Magnolia Public Schools

Ad-Hoc (Facility) Committee Meeting

Approval of MSA-1 Owner Change Orders No. 6 and No. 7

Ad Hoc Committee Agenda Item #:	III.A.—Action Item
Date:	June 3, 2019
To:	Magnolia Educational & Research Foundation dba Magnolia Public Schools (“ MPS ”) Ad Hoc Committee (the “ Committee ”)
From:	Alfredo Rubalcava, CEO & Superintendent
Staff Lead:	Patrick Ontiveros, General Counsel & Director of Facilities
RE:	MSA-1 Change Order Requests 6 and 7

ENLARGED SITE CONSTRUCTION PLAN
 DRAWN BY: [Name]
 DATE: 01/10/2019
 JOB NUMBER: [Number]
 DRAWING SCALE: AS NOTED
 PREPARED BY: [Name]
 DRAWING NUMBER: A0.5A

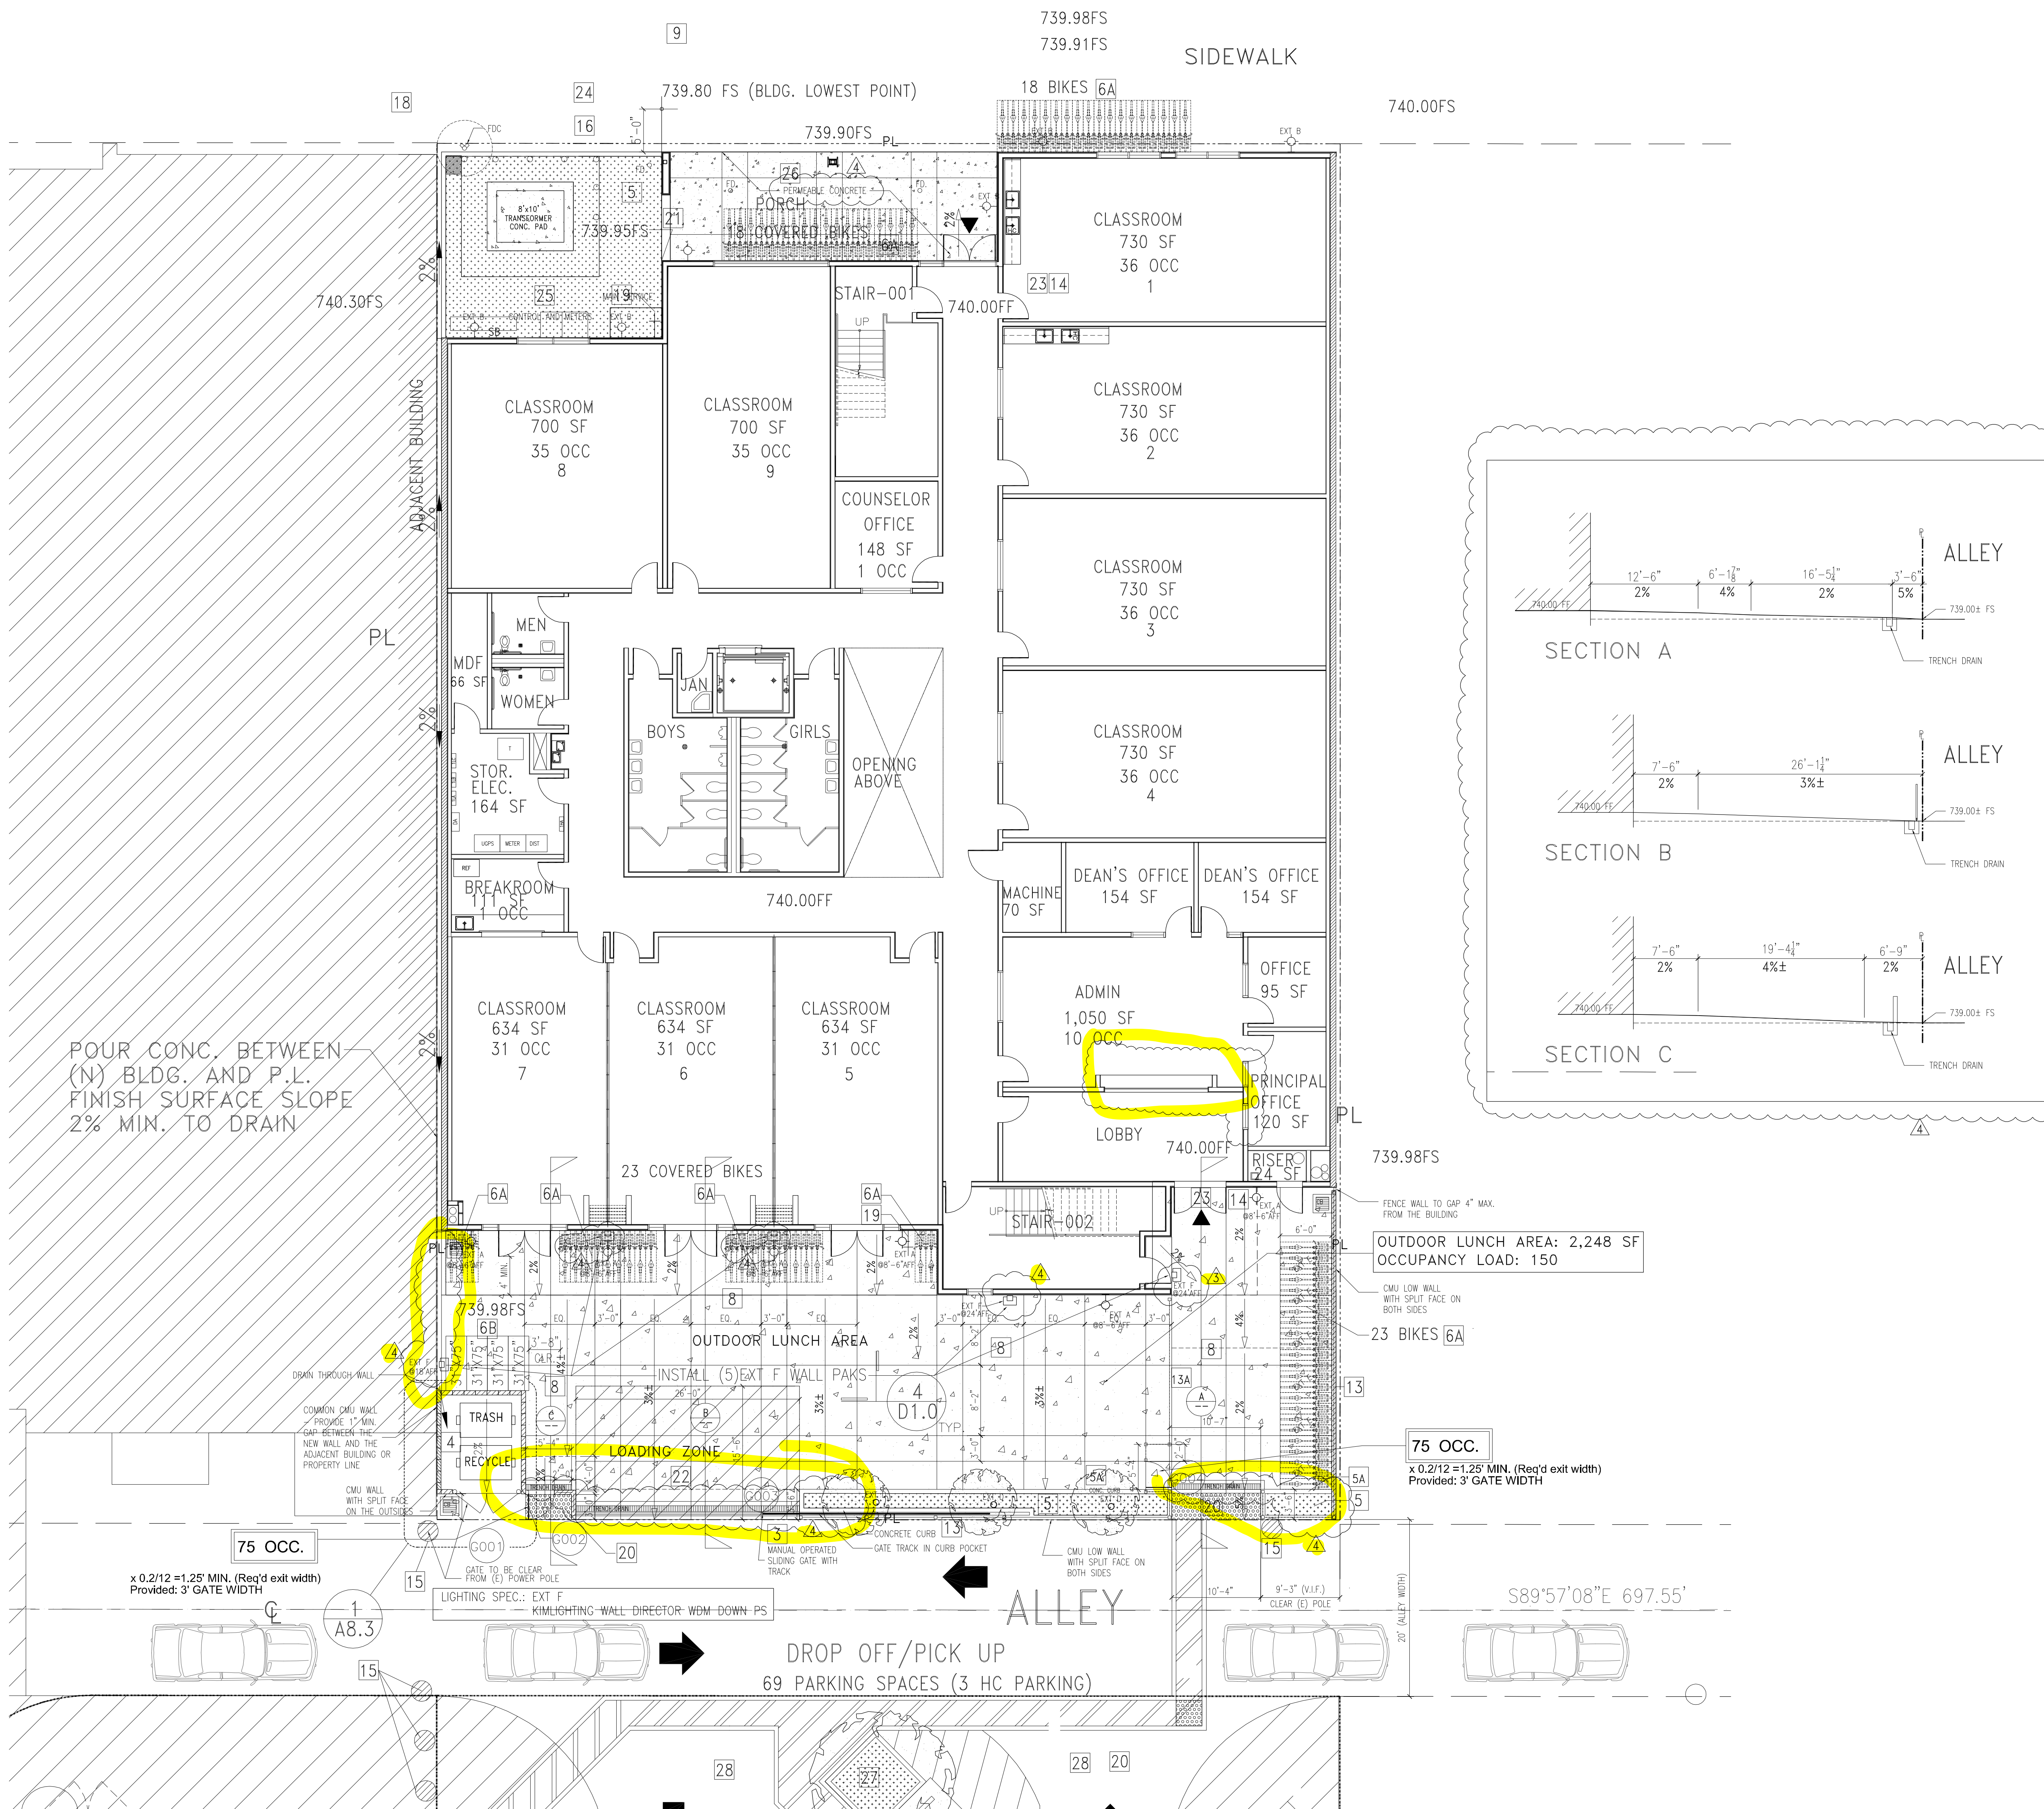
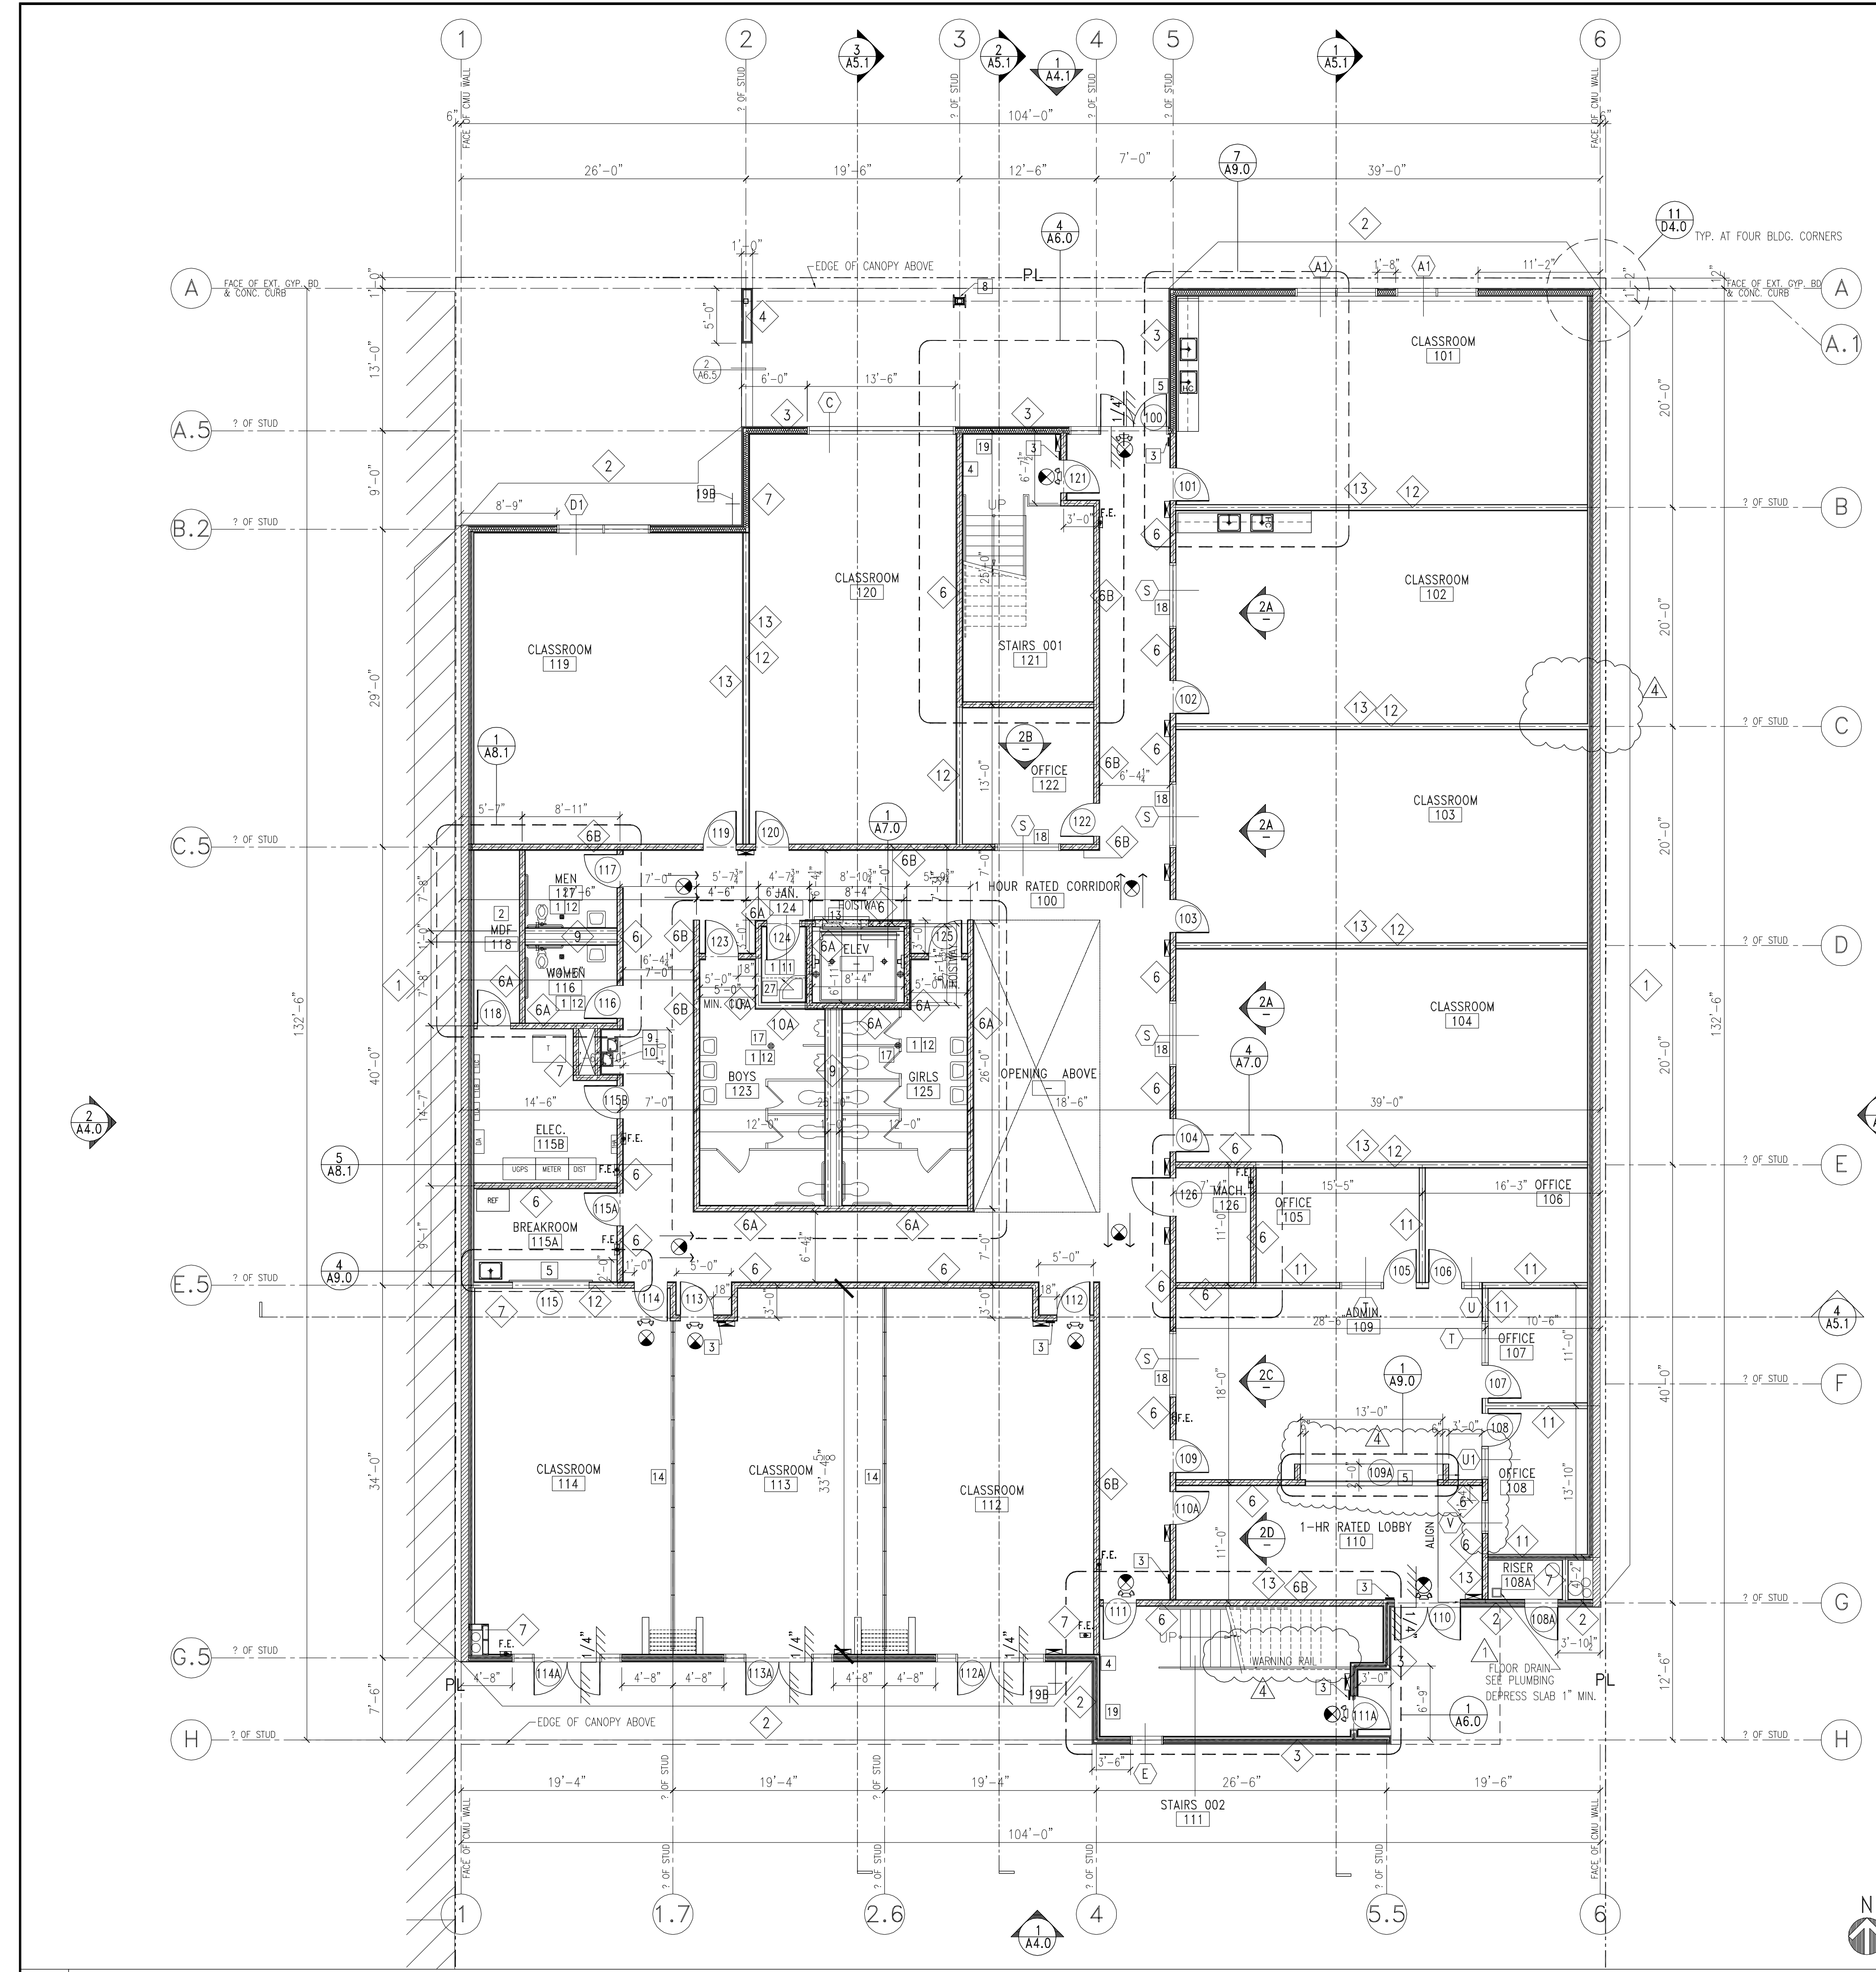
INCLUDES:
 - PERMEABLE CONCRETE AT NORTH PORCH
 - REMOVE 2 LIGHT POLE AND MOUNT SITE FLOOD LIGHTS ON THE BUILDING ELEVATIONS
 - ADD SITE SLOPE AT THE OUTDOOR AREA SOUTH OF THE BUILDING - SHOWN IN 3 SECTIONS.
 - REMOVE THE WEST FENCE.
 - SHOW TRENCH DRAIN PER CIVIL DESIGN.
 - USE MANUAL SLIDING GATE AT THE ALLEY.
